GE
159 Plastics Avenue
Pittsfield, MA 01201
USA

May 4, 2006

**Re: GE-Pittsfield/Housatonic River Site
Newell Street Area II (GEC450)
Proposal for Engineered Barrier Modifications**

**AREAS SUBJECT TO PROPOSED
ENGINEERED BARRIER
MODIFICATIONS**

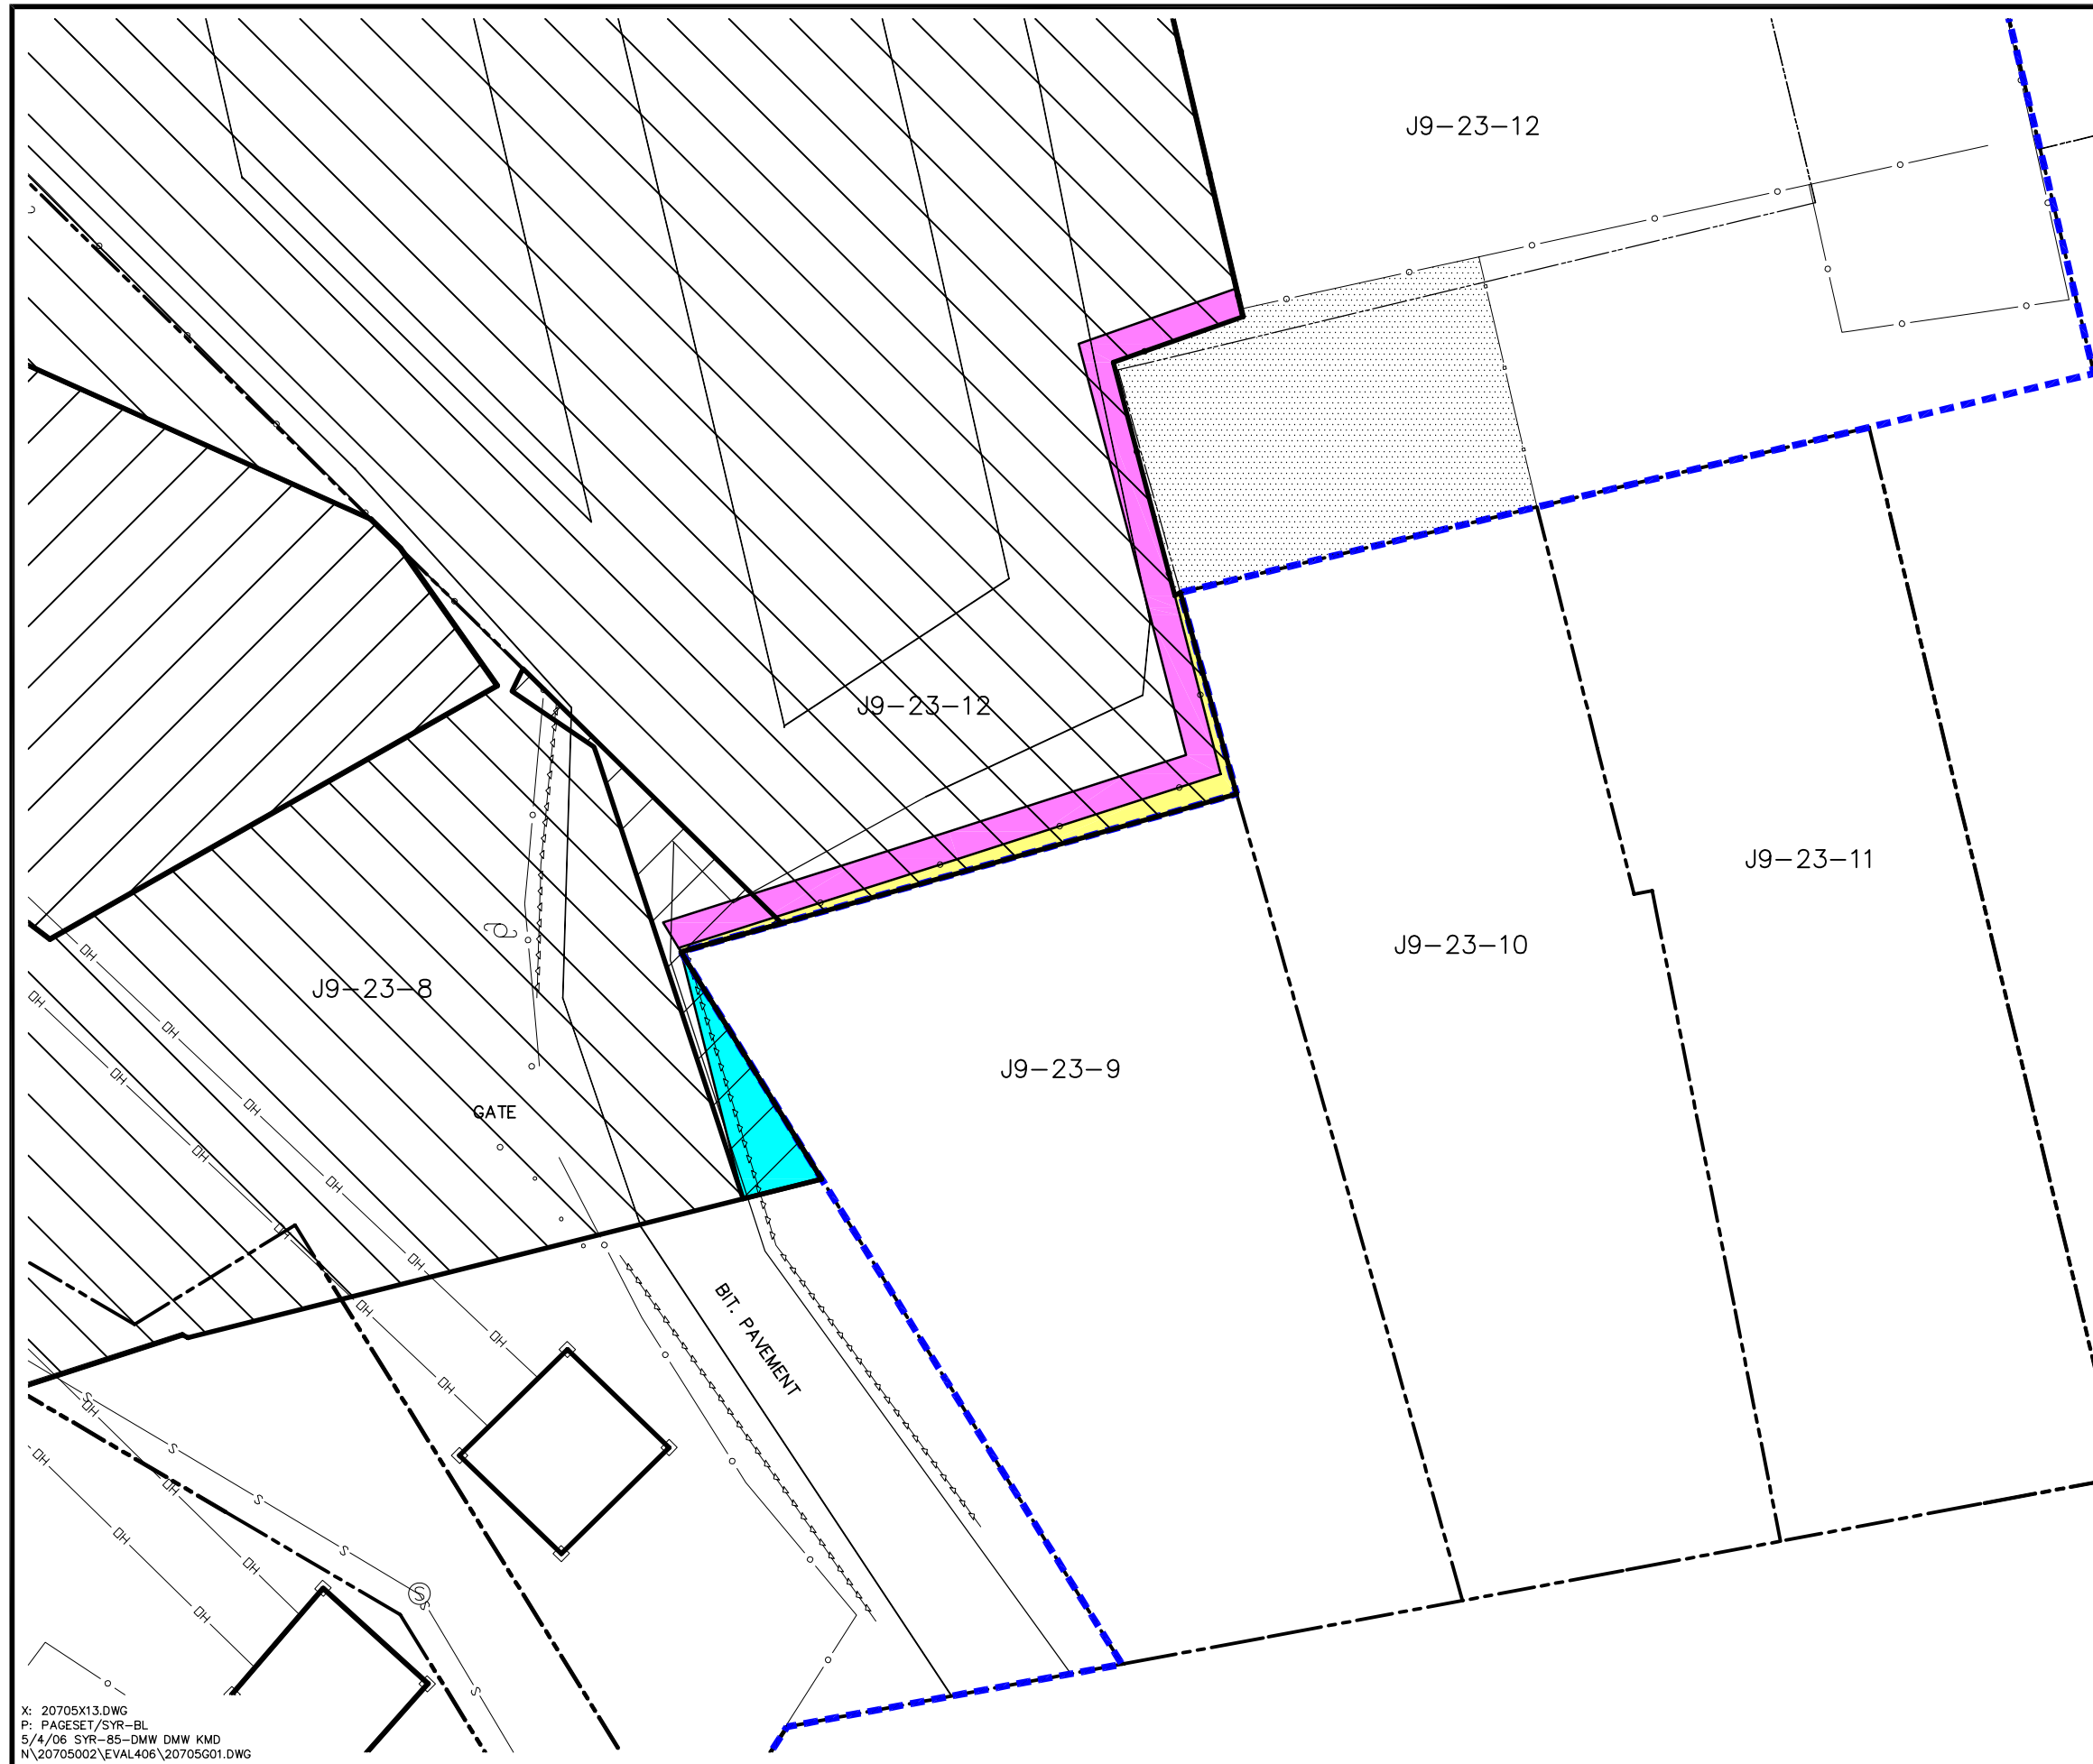
The first relates to a portion of the engineered barrier that was proposed for the GE-Newell Street parking lot at Parcel J9-23-12 but slightly extends into an area used by the owners of adjacent residential Parcels J9-23-9 and J9-23-10 as part of their backyards. This area is shown in yellow on Figure 1 and is described further below.

Instead, GE has evaluated the area between the property line (dividing Parcel J9-23-12 from Parcels J9-23-9 and J9-23-10) and the existing fence line, shown in yellow on Figure 1, to determine whether soil removal/replacement would be needed in that area to achieve the Performance Standards. As a conservative measure, even though this area is located within GE-owned Parcel J9-23-12, GE has evaluated this area in accordance with the PCB Performance Standards for residential areas due to the current land use of this area. PCB evaluations for this area were performed in accordance with the spatial averaging procedures specified in the SOW. The results of the evaluations are provided in Attachment B and are summarized in the following table.

The second proposed modification to the engineered barrier limits relates to an approximately 5-foot-wide strip within Parcels J9-23-8 and J9-23-12 adjacent to the existing fence line that separates those parcels from areas used by the owners of Parcels J9-23-9 and J9-23-10. That strip is shown in pink on Figure 1. (As discussed above, the owners of Parcels J9-23-9 and J9-23-10 use a small strip on the GE-owned Parcel J9-23-12 as part of their backyards. In addition, as shown on Figure 1, the owner of Parcel J9-23-10 uses a larger portion of Parcel J9-23-12, outside the GE-Newell Street parking lot area, for such purposes.)

Based on the above considerations, GE proposes to modify the limits of the engineered barrier in the above-described areas to exclude from the barrier the areas shown in yellow and pink on Figure 1. The modified barrier limits are presented on the revised technical drawings provided in Attachment A.

**PROPOSED REMOVAL LIMITS
WITHIN PARCEL J9-23-12**

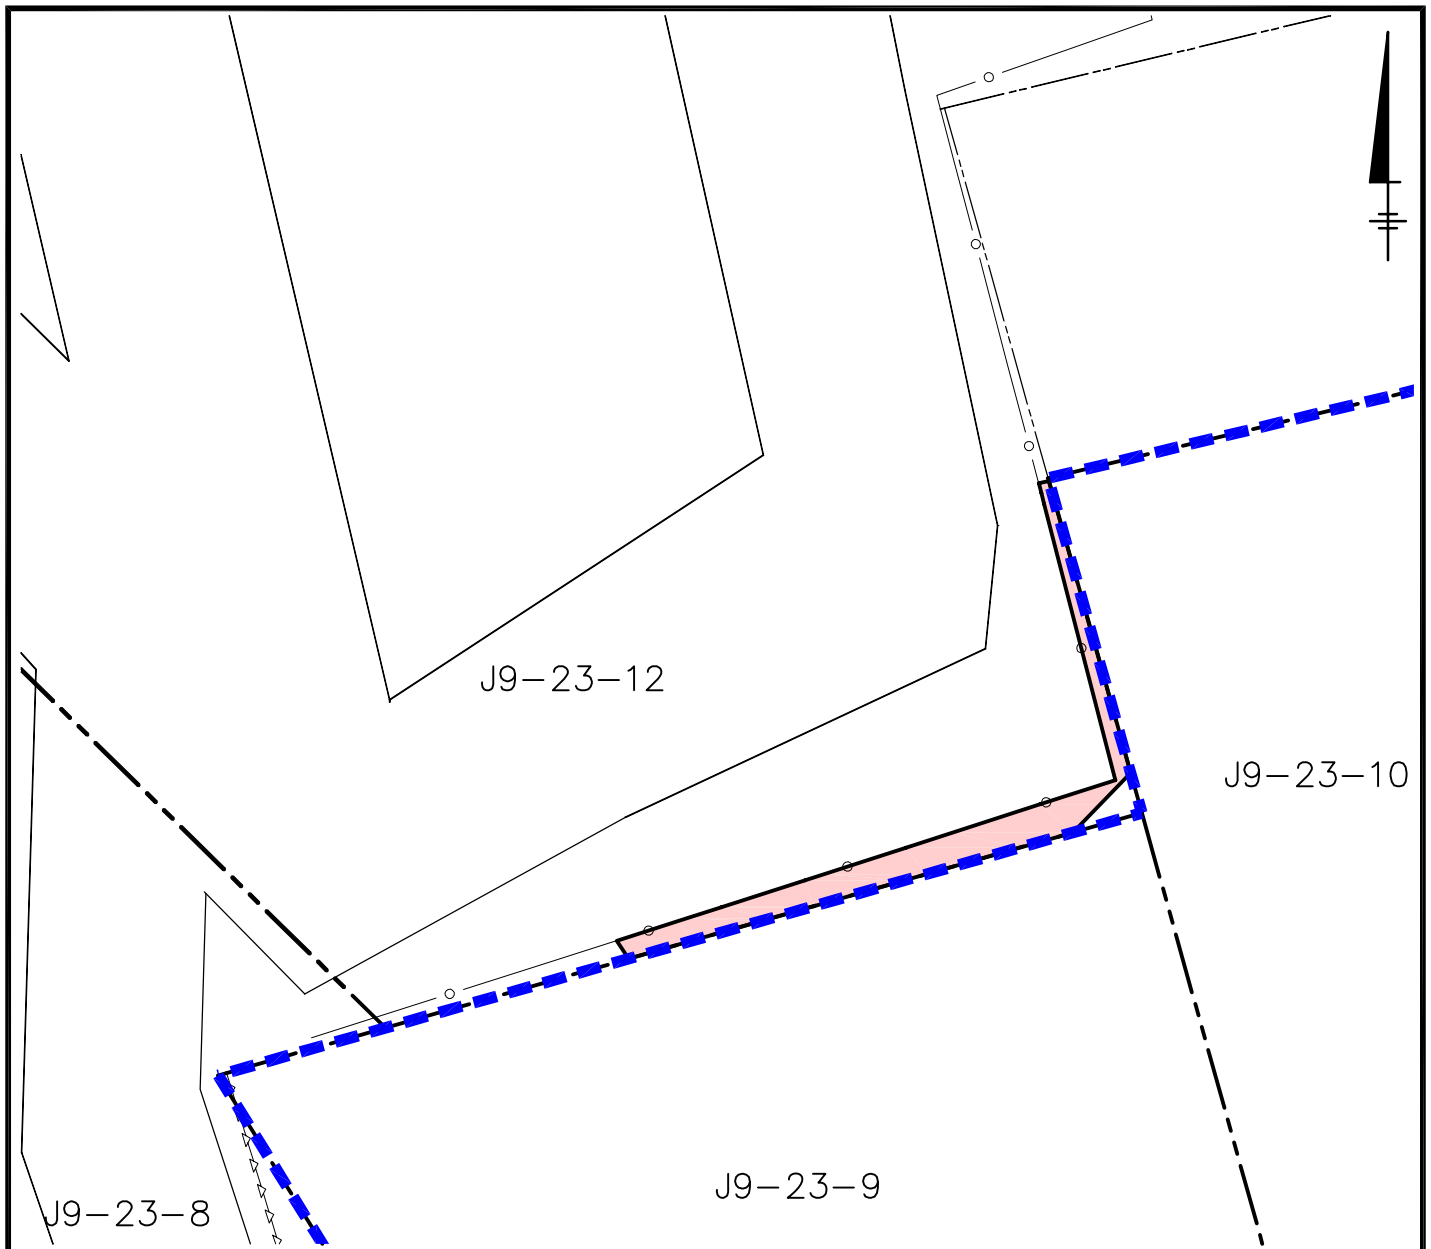
As indicated in the preceding table, the existing average PCB concentration for the 0- to 1-foot depth increment exceeds the residential Performance Standard. In addition, PCBs were detected within the 0- to 1-foot depth increment above the residential non-to-exceed (NTE) concentration of 10 ppm at two locations: J9-23-9-SB-2 and RAA13-F96. As a result, GE has elected to perform soil removal/replacement activities to a depth of 1 foot in select portions of the subject area to meet the residential Performance Standards. Proposed activities involve the removal of approximately 8 cubic yards of soil from the area specified on Figure 2, backfilling the excavation with topsoil, and restoring that area with seed and mulch.

The soil removal/replacement activities discussed above will result in the achievement of the residential PCB Performance Standards in the subject area, as indicated in the following table, thus obviating the need for installation of an engineered barrier in that area.

SITE PREPARATION PLAN

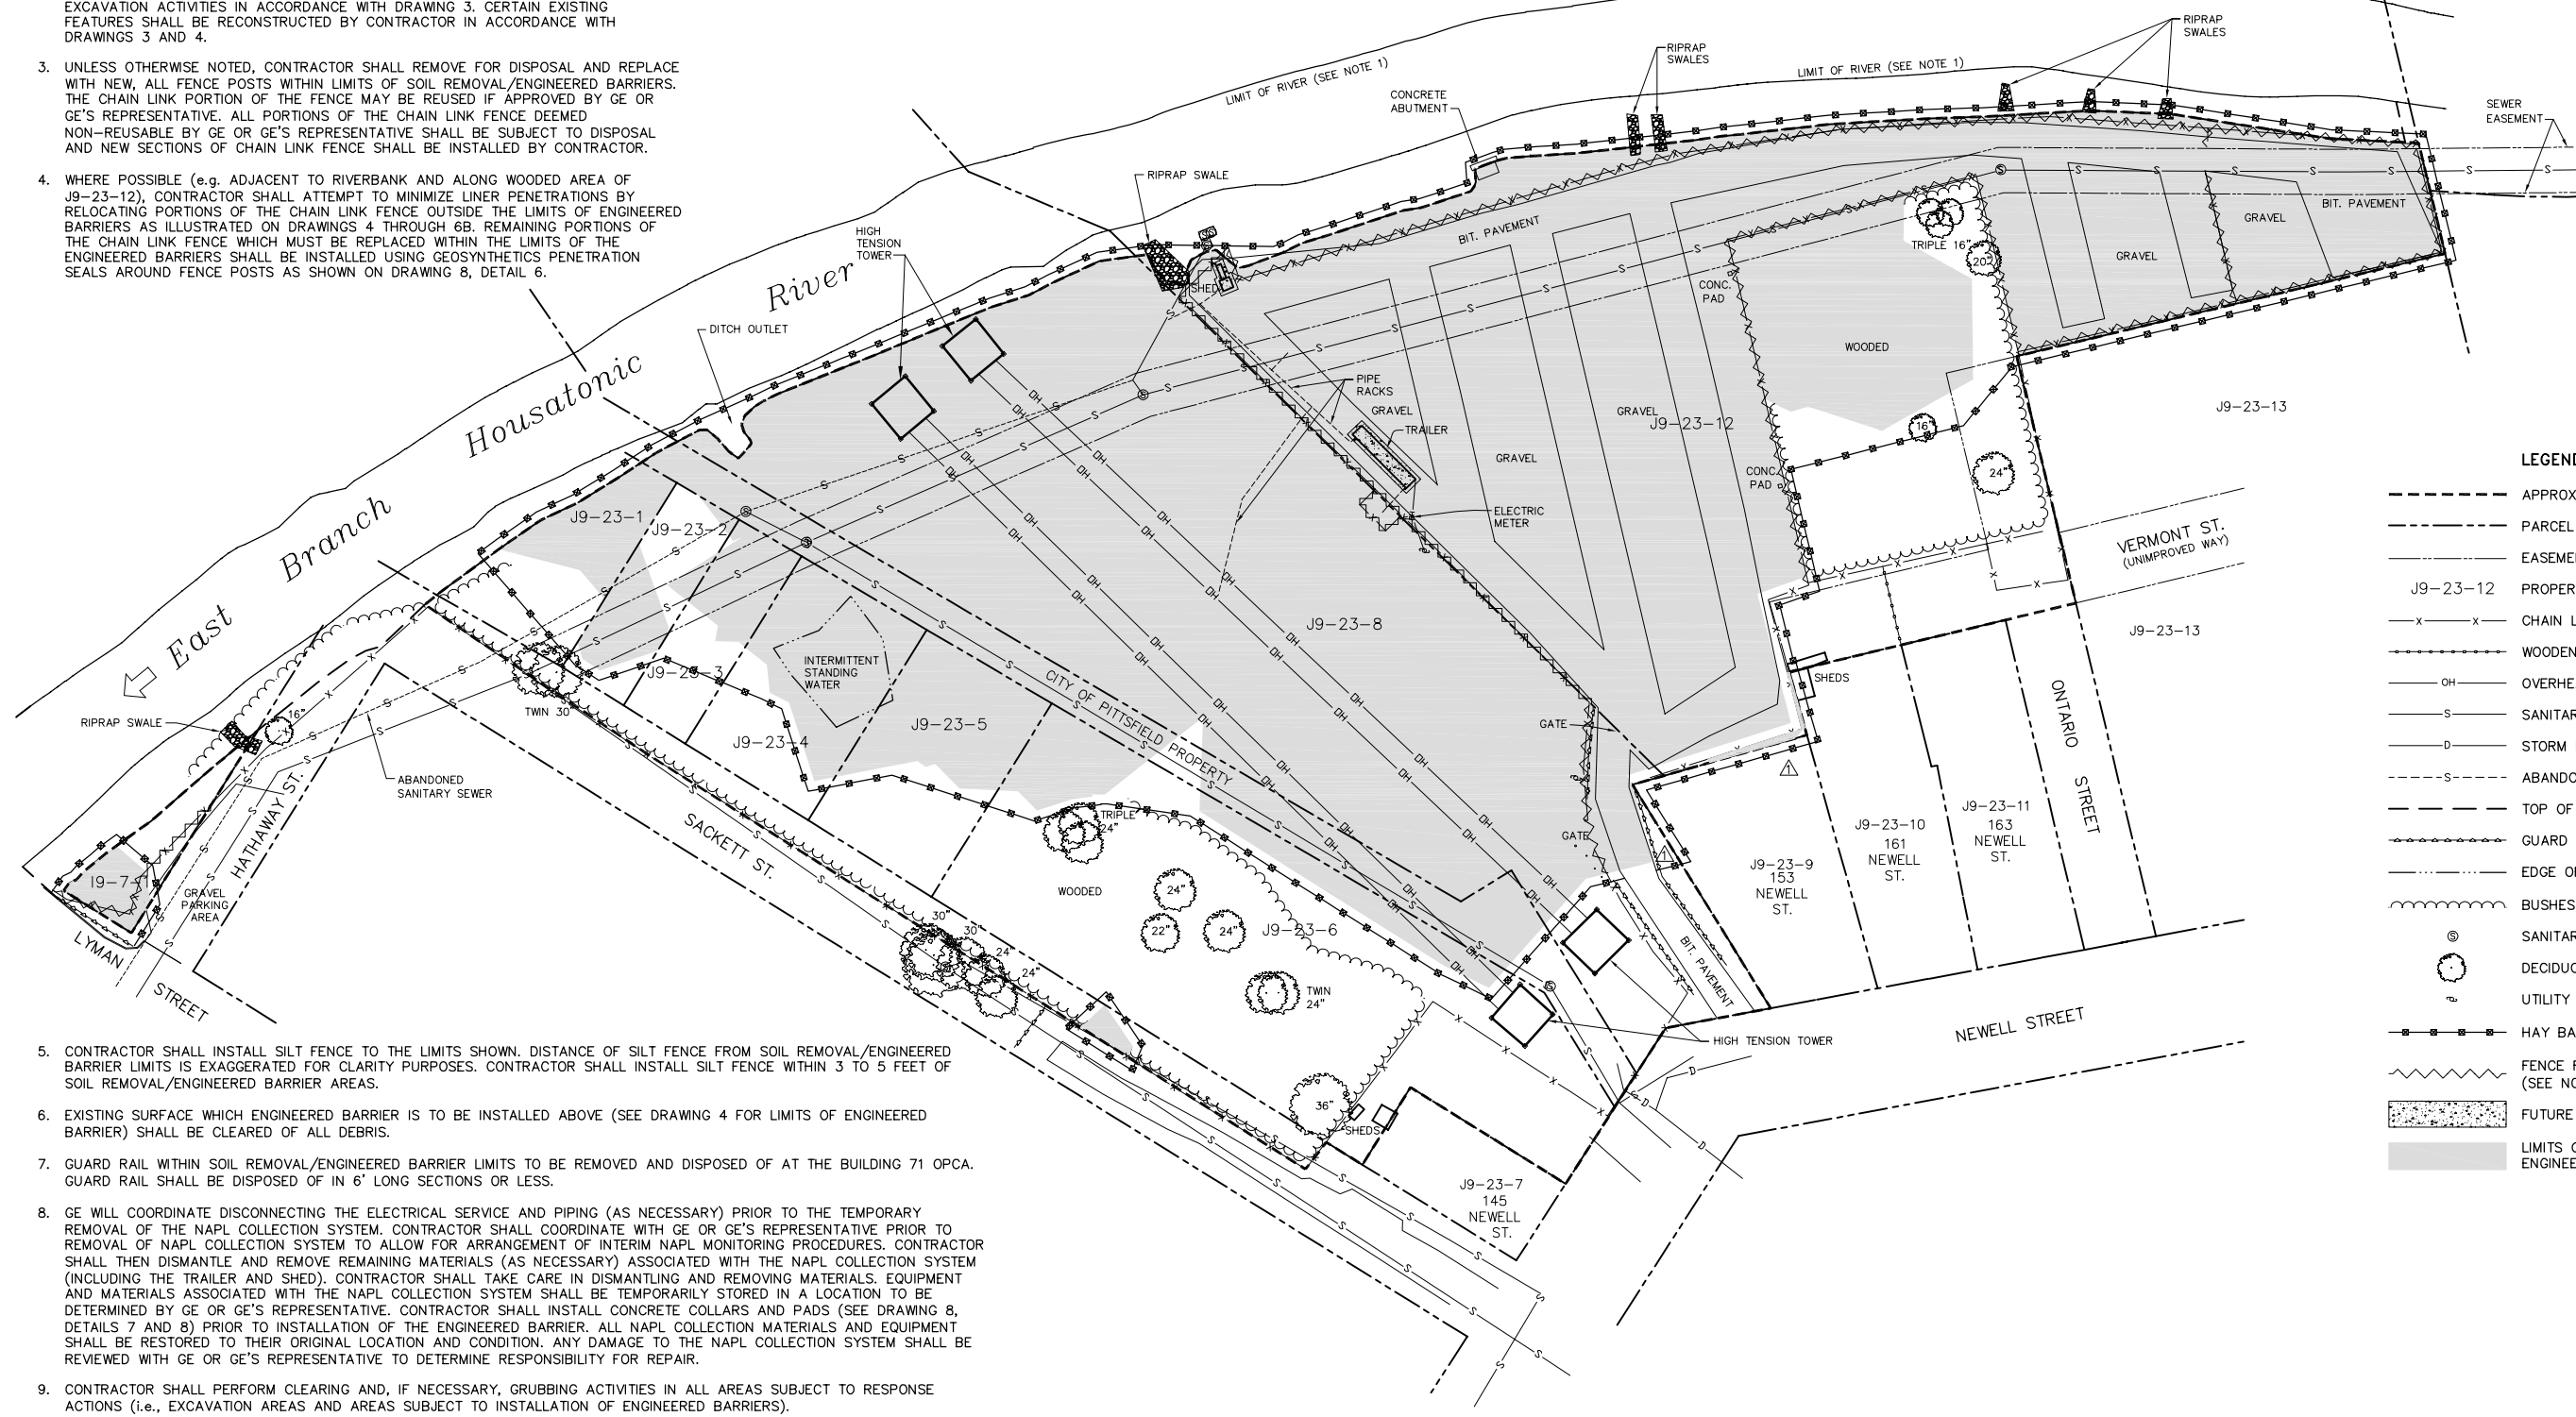
4/21/06	REVISED LIMIT OF ENGINEERED BARRIER INSTALLATION	CAA
Date	Revisions	Init
